5 Thank you for your assessment of nhes 2018_383, "The Effects of Changing Climate on Estuarine Water
Levels: A United States Pacific Northwest Case Study" by Parker, Hill, Garcia-Medina, and Beamer. We
sincerely appreciated the obvious effort that the reviewers have put into the paper and their resulting suggested
areas for improvement. As detailed in the open discussion of the manuscript, we have incorporated all reviewer
10 our improvements to the manuscript as guided by reviewer comments. These comments are similar to those from
the open discussion although with some changes. This is followed by the revised manuscript.

Anonymous Referee #1

Bruno Merz (Referee #2)

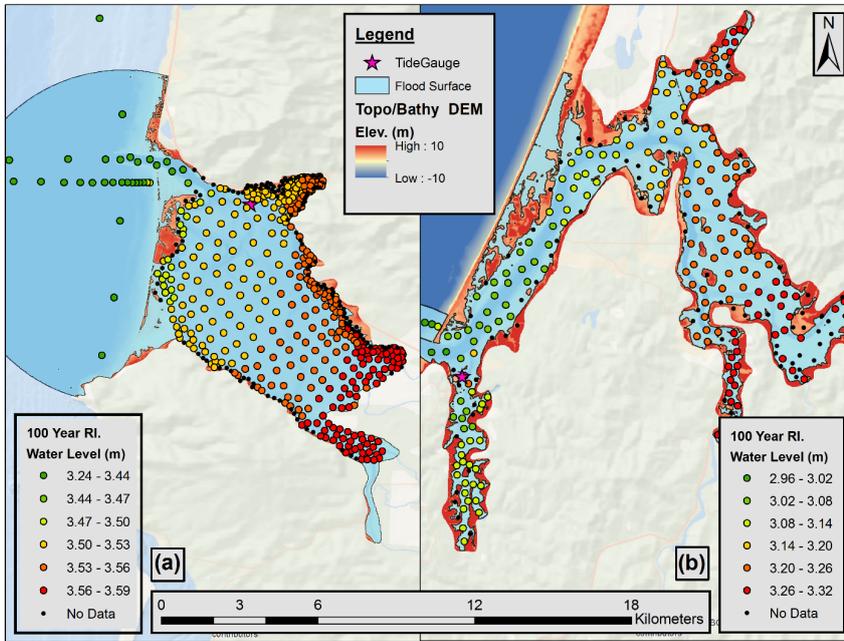
5 * *Section 5.1, last paragraph and Figure 6: Again I do not understand the explanation of effective RIs and the locations of intersection between historic and future effective RIs. Why are the historic water levels higher than the future water levels when we have SLR?*”

10 Response: We agree with the reviewer that this presentation of results is somewhat non-intuitive. In considering this figure we were worried that, as detailed in the comment, the immediate take away would be that future flooding is less than historic. This is definitely not true. The future RI curve represents recurrence water level events without SLR included. We decided to present the data in this way for two reasons. The first is because we feel that it shows a valuable outcome of the study, specifically (“future RIs as a function of only changing forcing (no SLR)”). The second is that to plot nonstationary Future recurrence intervals (SLR included) on the same plot as stationary historic recurrence intervals is conceptually problematic. Stationary and nonstationary recurrence intervals are not directly equatable so we feel this would be incorrect. Instead we plot the stationary version of the Future recurrence intervals (that with SLR not included).

20 To clarify this further, we have added (No SLR) to the Future symbol in the legend of Figure 6. We have additionally augmented the text in the description of the figure to further emphasize this point (as well as our reasons for presenting the data in this way). This said, if the reviewer has any further suggestions for how we could better get this point across better, we would very much like to incorporate it in the paper. This is an important detail that we don’t want to get lost.
